5TH AND VIRGINIA

Proposed MUP #3018037

# SECTION 02. RESPONSE TO EDG

6(A) NORTHEAST STREET CORNER /

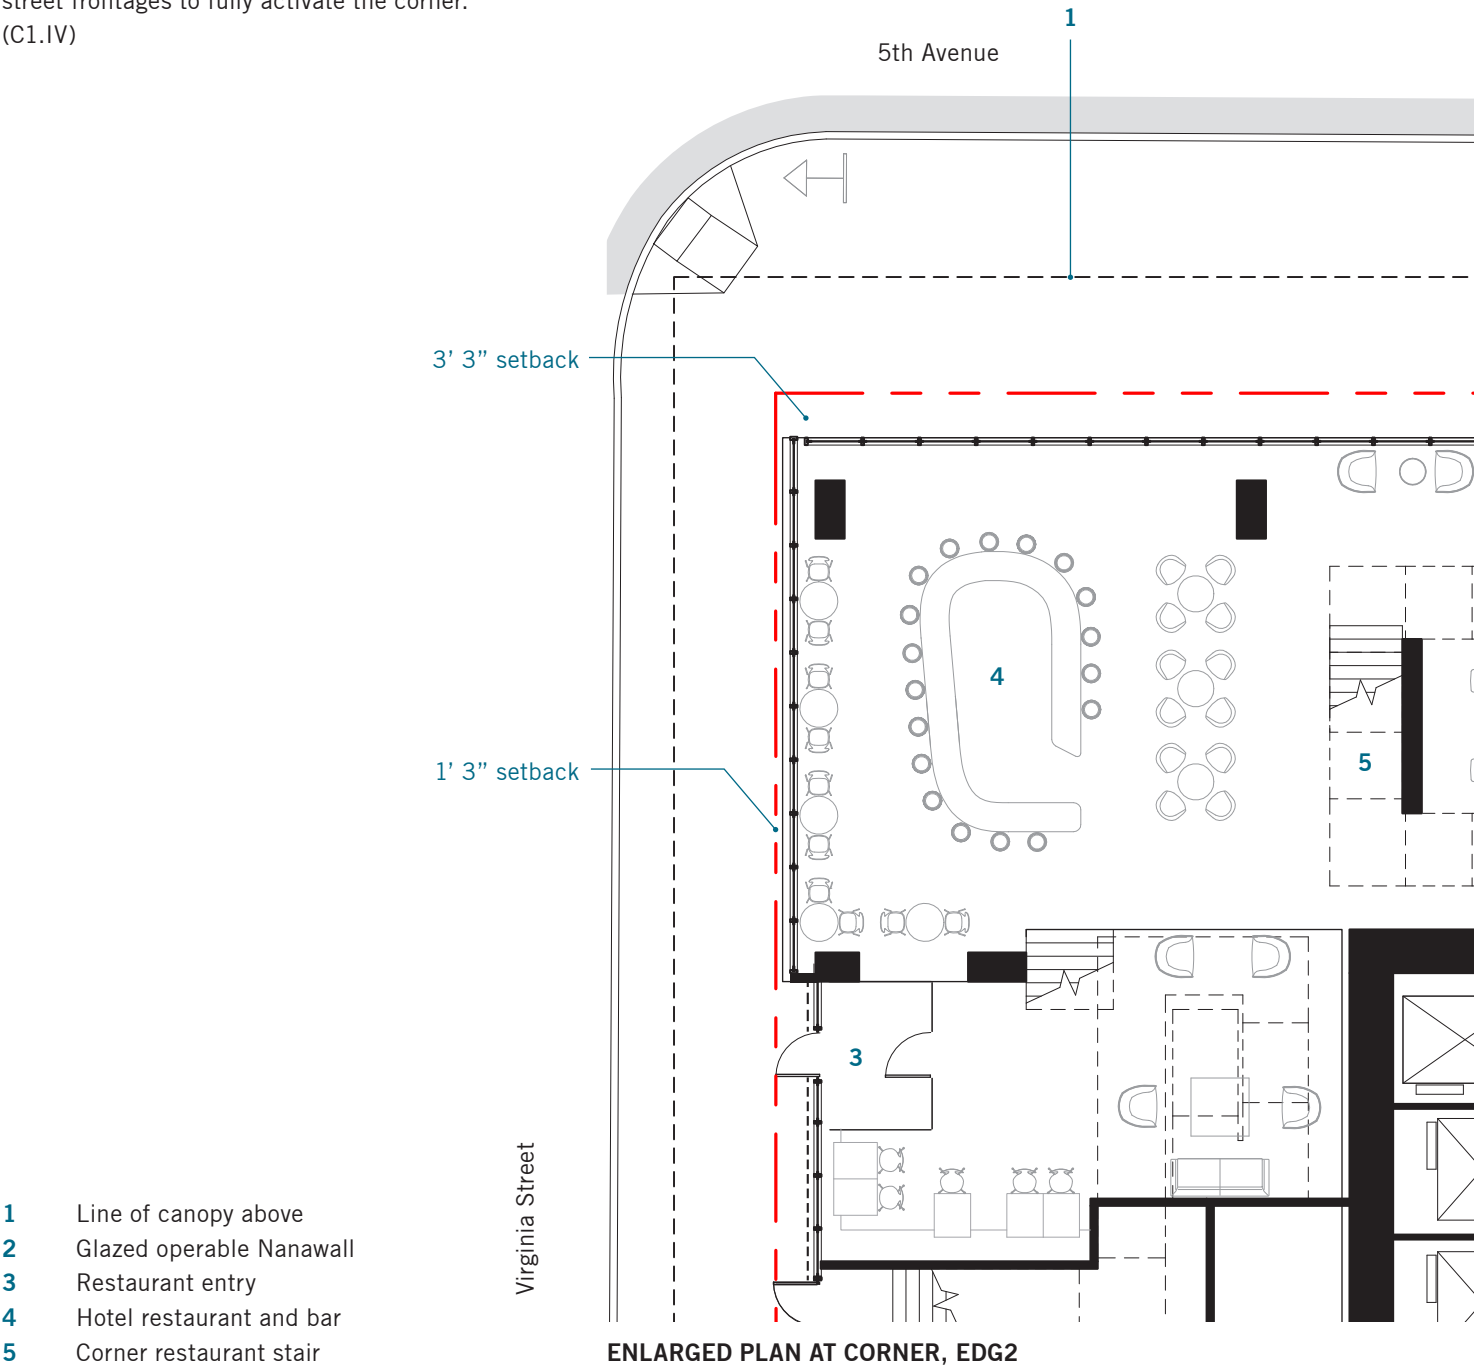
The Board supported the 3-level tall and transparent base as basically depicted on pg58/59/61, assuming canopies, entries and other scale elements are fully developed beyond the faint lines shown. The Board agreed the northeast street corner is a dynamic pedestrian location, and recommended the addition of doors and/or generous sliding windows on both street frontages to fully activate the corner. (C1.IV)

Restaurant and bar entry moved closer to corner, added operable glazing along 5th Avenue.

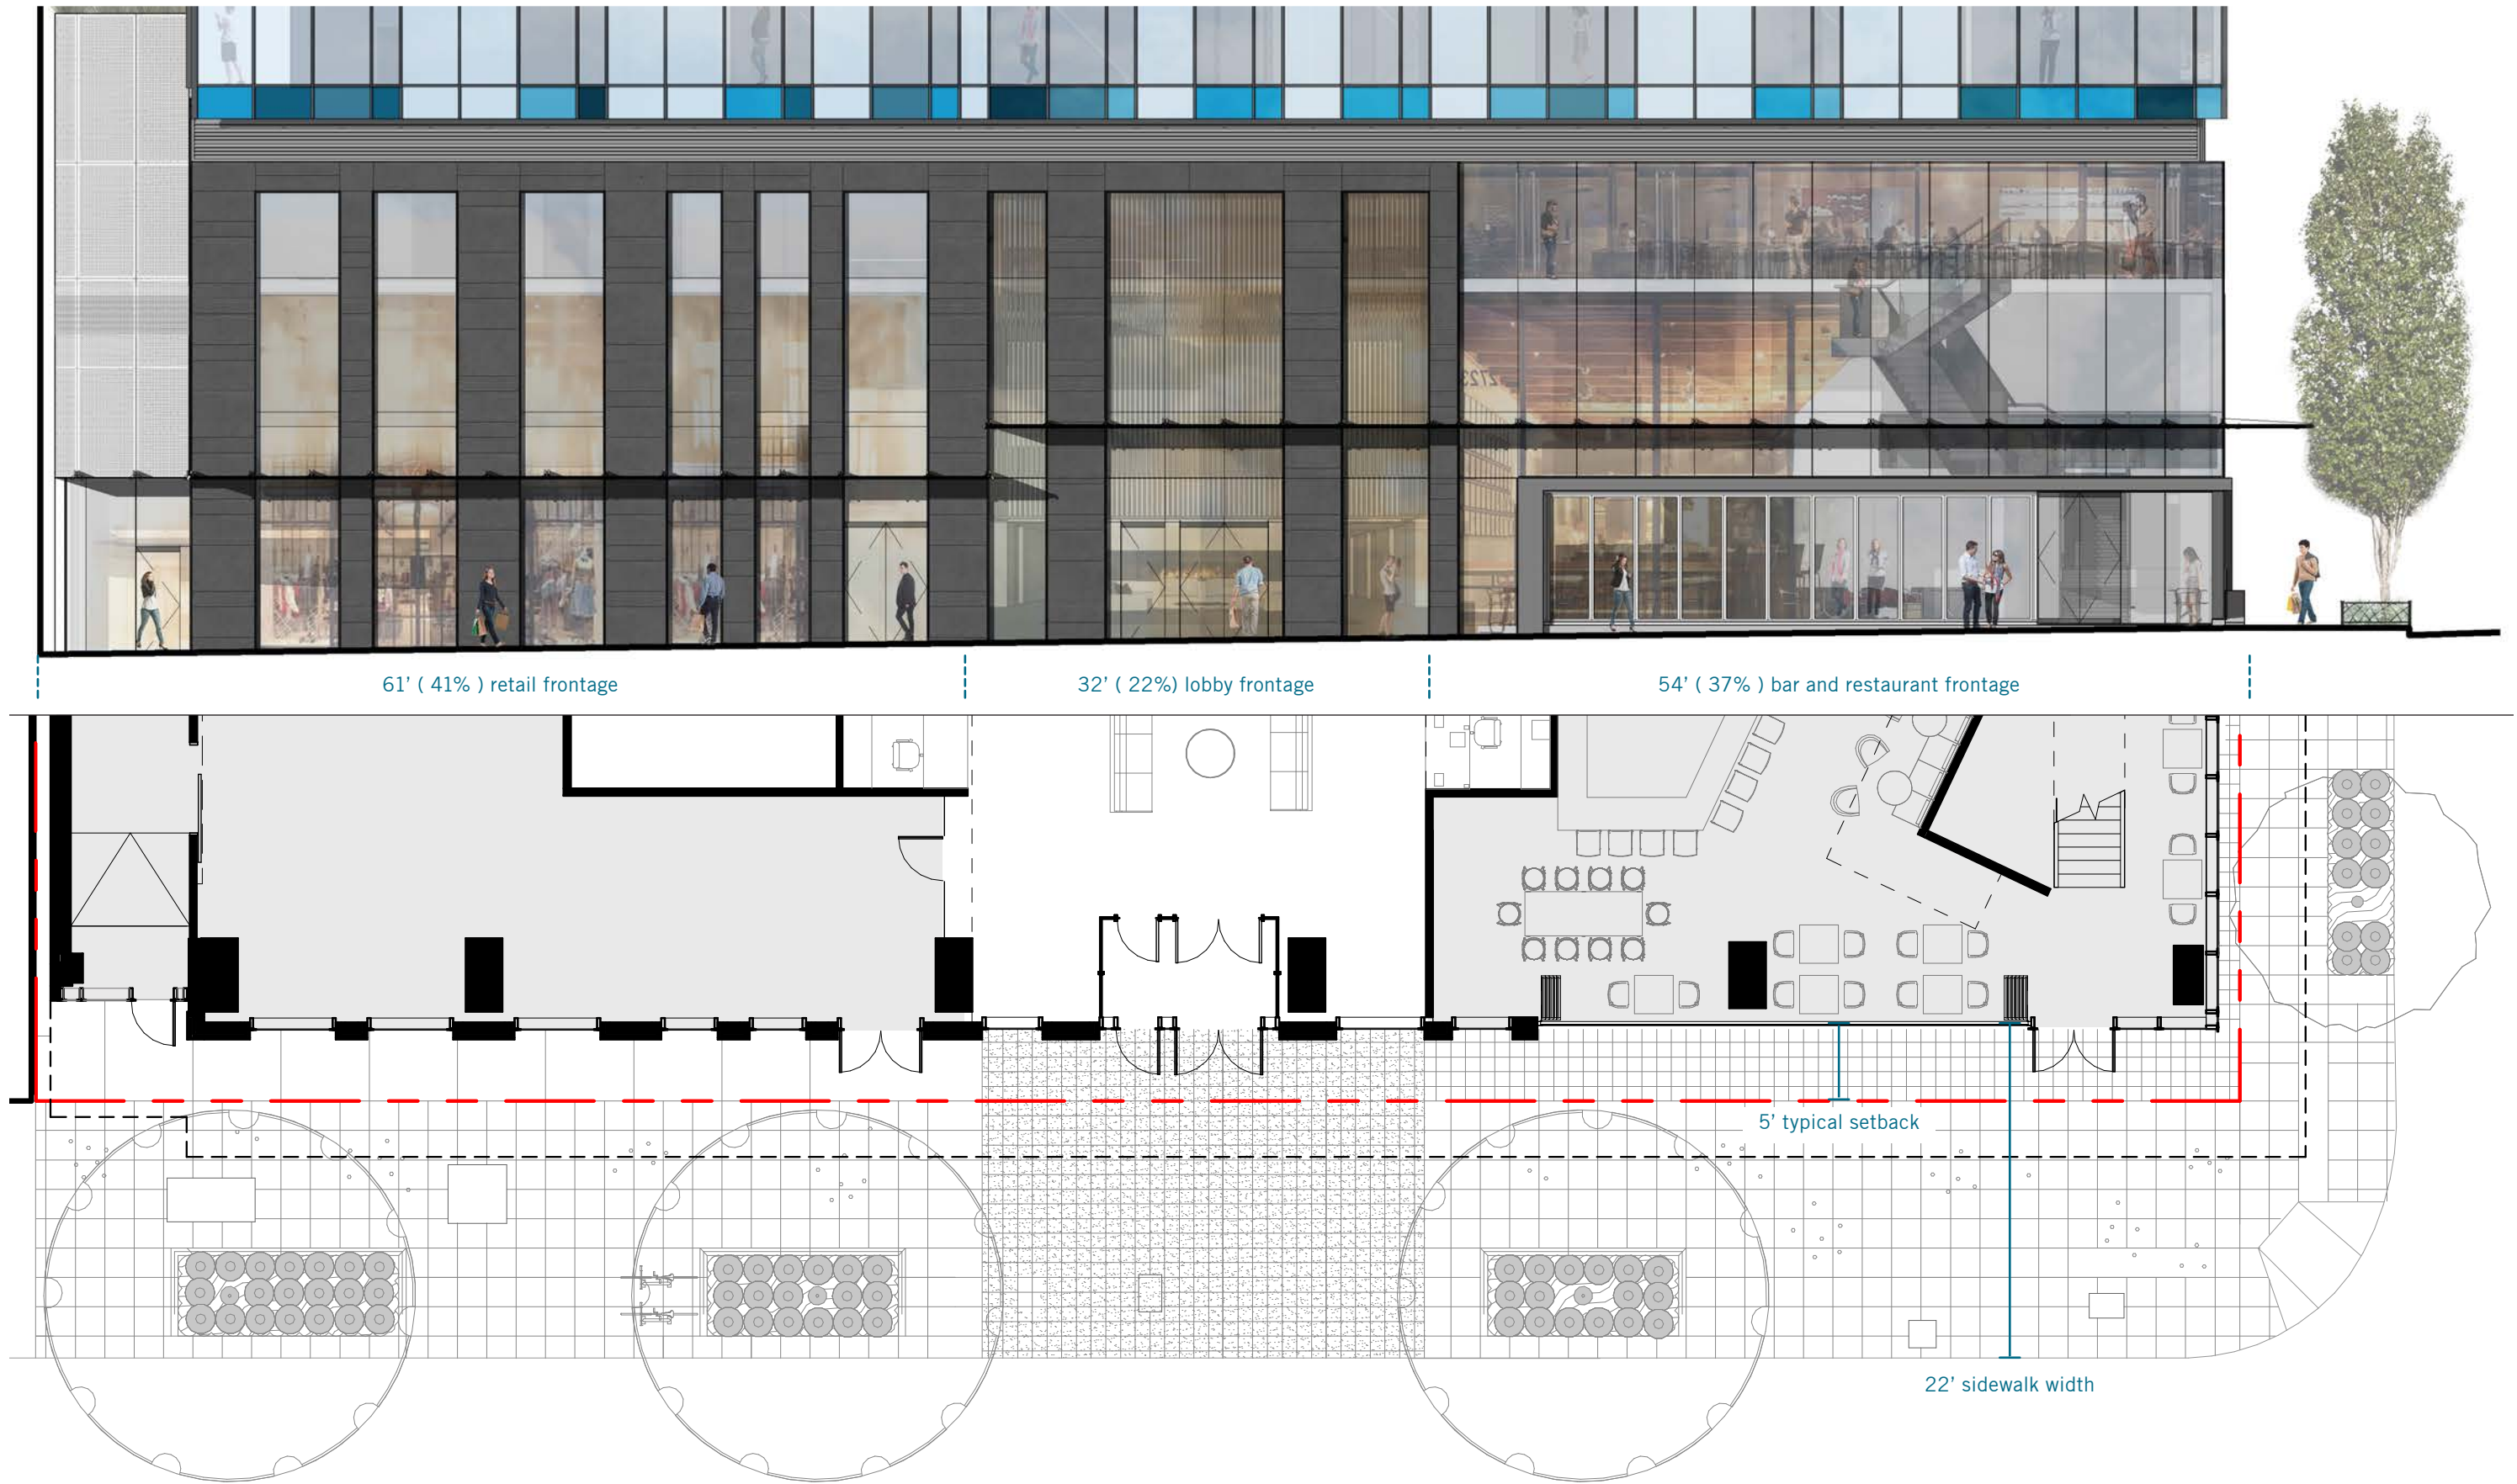
The Board strongly supported the 3 ft setback shown (more encouraged) and the code requirement for 75% of the frontage along 5th to be authentically retail/ commercial uses with direct street access. Therefore, the Board recommended the south retail be expanded north, the second bay from the corner also have doors to the sidewalk, and the lobby function be reduced to 25% or less street frontage. Retail that also opens into the lobby is acceptable, as long as sidewalk activating doors are provided. (C1)

The Fifth Avenue Retail and Commercial frontage has been further setback, the lobby frontage reduced by the expansion of retail and restaurant/bar space to the north and south. Additional doors to the retail space from the sidewalk have been provided.

Entire 5th Avenue frontage set back further, lobby width reducedadditional retail doors added, operable glass wall added, scale elements, materials, and details developed.
